**5.5 LATE REPORT: NO. 48 (LOT 5; D/P: 14389) EGINA STREET, MOUNT HAWTHORN - SAT S.31 RECONSIDERATION - TWO GROUPED DWELLINGS**

**TRIM Ref:** D19/1624

To reconsider an application for development approval for two grouped dwellings at No. 48 Egina Street Mount Hawthorn (subject site) at the invitation of the State Administrative Tribunal (SAT).

**Site Plan**

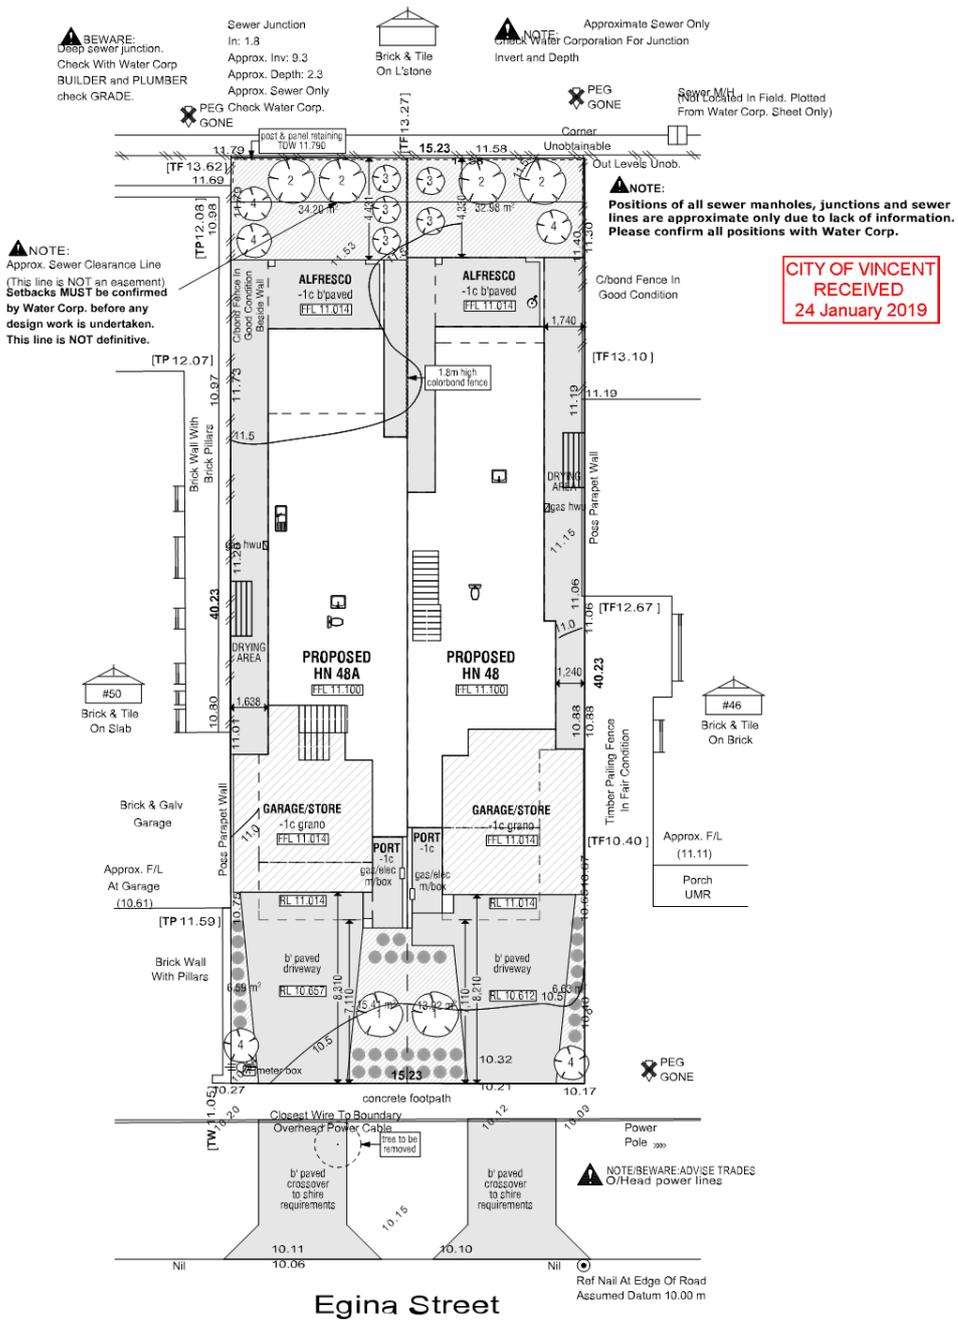
The Built Form Policy requires a minimum of 15 percent deep soil zones and 30 percent canopy cover within the lot boundaries. The development proposes 16.4 percent deep soil and approximately 25 percent canopy cover. The proposed tree species are consistent with the City's tree selection tool, however the City has concerns that the proposed species will grow to a substantially higher height and canopy than that shown on the development plans. This may impact on the viability of the trees as the trees are proposed to be planted within close proximity to each other.

The proposed landscaping responds to the relevant design principles through the provision of tree canopy and deep soil zones that would contribute to the City's green canopy and would reduce the impact of the development on the surrounding residential area. The proposal is acceptable from a landscaping perspective. A condition of development approval has been recommended requiring a revised landscaping plan to be submitted and approved by the City prior to the issuing of a building permit. The revised landscaping plan will allow the applicant to reconsider the placing of the proposed trees.

<p><u>Landscaping</u></p> <p>The landscaping appears unrealistic and not implementable. Concerns in regards to the viability of the mature trees being located within such proximity to each other.</p>	<p>Agreed, the City has concerns that the proposed species will grow to a substantially higher height and canopy than that shown on the development plans. This may impact on the viability of the trees as the trees are proposed to be planted within close proximity to each other. A condition of approval has</p>

4.1 A detailed landscape and reticulation plan for the development site and adjoining road verge to the City's satisfaction is to be lodged with and approved by the City prior to commencement of the development. The plan shall be drawn to a scale of 1:100 and show the following:

- A canopy cover of at least 25 percent; and

## HN 48 Ground Floor Plan

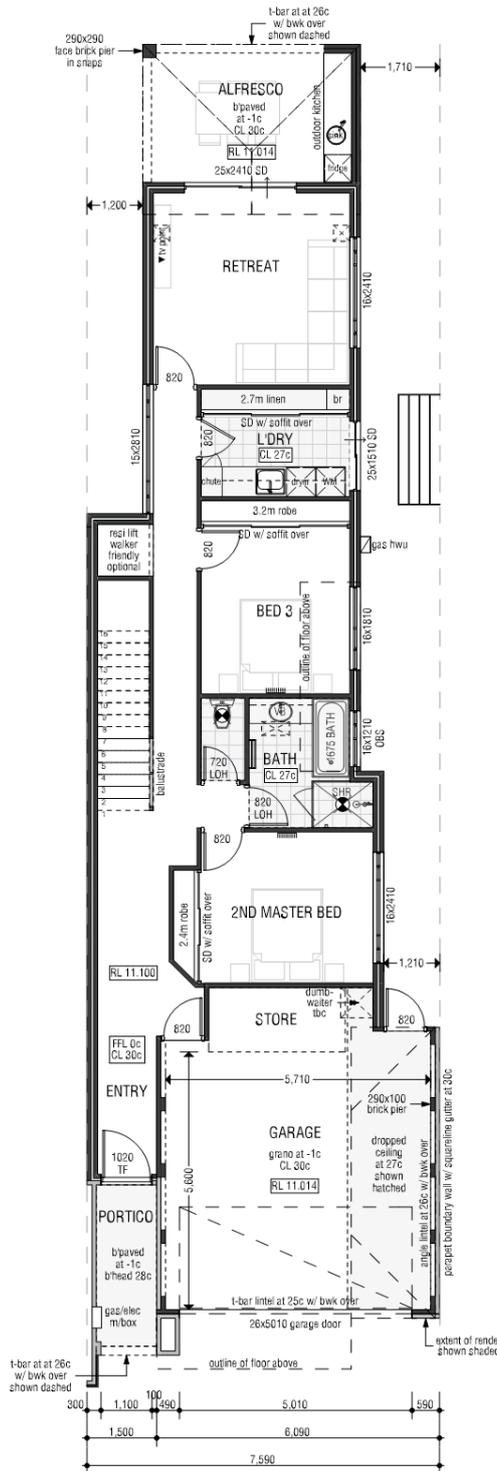
The deemed-to-comply provisions of the R Codes requires each grouped dwelling to be provided with storage area of a minimum of 4.0 square metres and a minimum dimension of 1.0 metre. The northern dwelling proposes 4 square metres of storage with a minimum dimension of 1.1 metres, however the use of

the storage area will be restricted by the stairs. The subject site has subdivision approval and clearance for two green title lots in a configuration consistent with the current development proposal. Once Landgate issues the titles for these lots, the proposed dwellings will be considered two single houses and will not require separate storage facilities. Given this, the proposed storage area of northern dwelling, albeit restricted, is acceptable.
